**ENGINEER'S CERTIFICATION:**

**GRADING & DRAINAGE PLAN**

**A BUILDING FOR CLARK SANCHEZ**

**ALBUQUERQUE, NEW MEXICO**

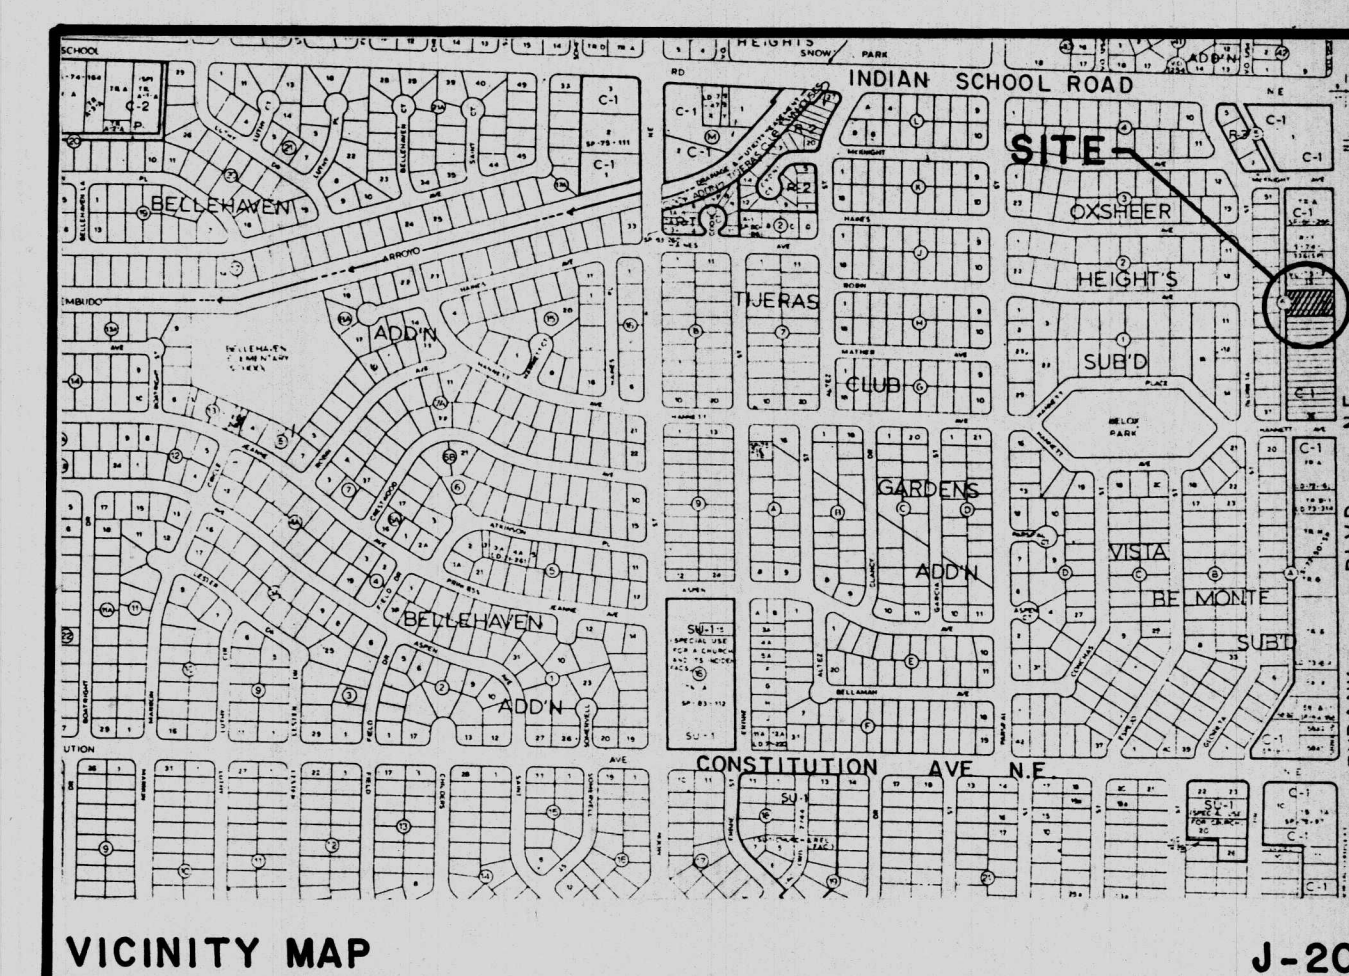
Having inspected the constructed facility and having taken spot elevations at all critical points on the site, I hereby certify that the as-constructed facility is in substantial conformance with the approved grading and drainage plan, Engineer's stamp dated 8-2-94 with the following noted exceptions:

1. The sidewalk culvert was not constructed and the east border of the parking lot is not curb but portable concrete parking barriers. Essentially, runoff from the parking lot runs under the barriers and into the gravel landscaping area between the asphalt parking lot and the sidewalk.
2. The roofs of the two adjacent buildings to the north and south drain to the front and rear of the buildings. The plan for accepting runoff from the roof drains and piping it through the building to the rear parking lot was not followed. The roof drainage on these buildings appears to work adequately.
